Pre-Redevelopment Audit

41 Sheldon Avenue

Revisions schedule		
Issue Date: 19 th June 2024		
Report prepared by: Han-Chieh Lee, Consultant, CarbonPlan Engineering		Date: 13 th June 2024
Checked by: Alan Calcott, Director, CarbonPlan Engineering		Date: 14 th June 2024
Status	First Issued for Comment	
Revision	Date	Changes
A	19 th June 2024	Amended to include Design Team Comments
B	11 th September 2024	Updated with the Planning responses, highlighted in BLUE

Section 2.1.3 extent the paragraph with more detail information addressing the following planning responses:

Facade to be retained - after demolition, image by MWA

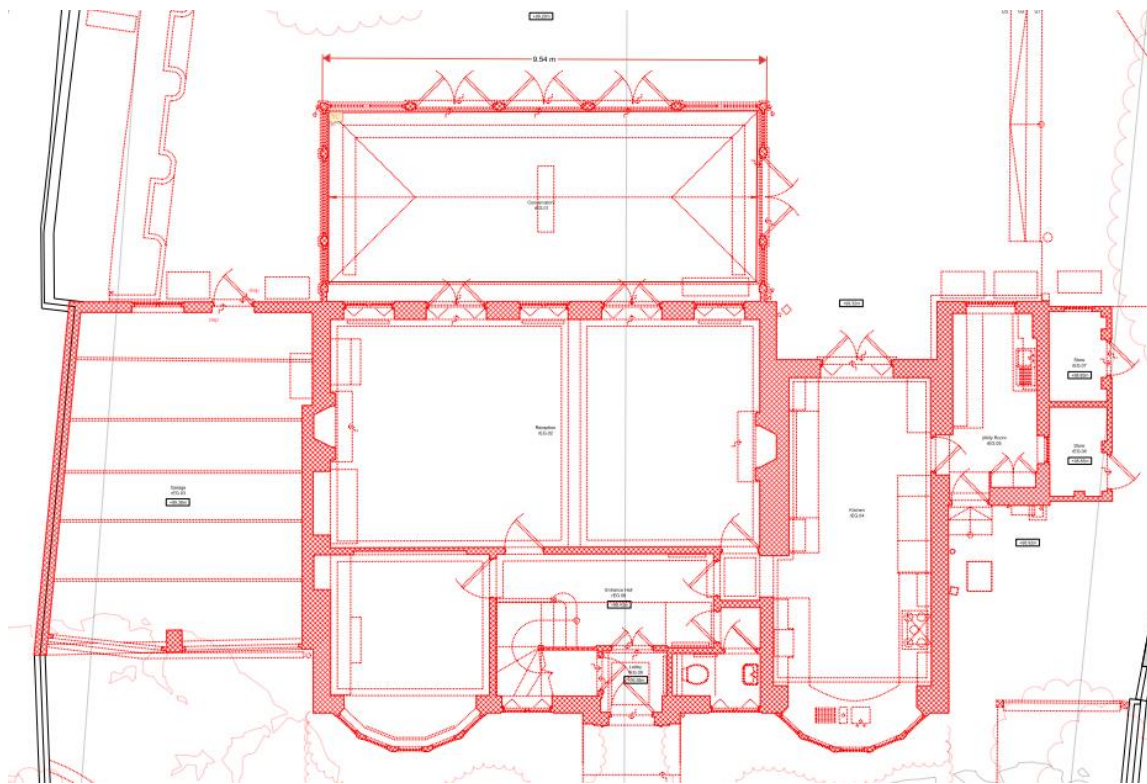
“The applicant should robustly explore the options for retaining existing building (either wholly or in part) The pre-development audit has not demonstrate how these options have been explored and how the existing brick load bearing wall has limited its flexibility to rearrange the layout”

The Design Team have considered the option of partial retain and refurbishment, however, there are limitation and drawbacks as follows(Referred to the document “23002_41 Sheldon Avenue Planning Response_”):

- ❑ The retained front façade well possibility cause worse linear thermal bridges value and u value when connecting to the new façade. The u-value and air tightness will improve but won't be new build standard. Moreover, this measure reduces the internal floor area due to the extra thickness of the insulation and plasterboard finishes added on top of the existing 350mm solid brick wall.

- ❑ Low floor to ceiling level which is lower than 2.5m (London Plan suggested height), retained the front façade also limit the main entry floor to ceiling height to 2.1m. – not appropriate to the modern standard.

- ❑ To retain the Front façade will require additional structure (temporary) to support before it can be connected to the new structure. (Please see section 3.1.1 of the WLC report for the result of this option which shows a higher carbon impact than full demolition option)

- ❑ It would be difficult to retain the bay window of the front façade, will most likely need to be replace which also reduce the actual area can be retained and need new steel frame.

- ❑ There is some non-original brick on the front façade which will need to be replaced to match the retained façade. (further reduce the retainable area, diagram shown in the following page)
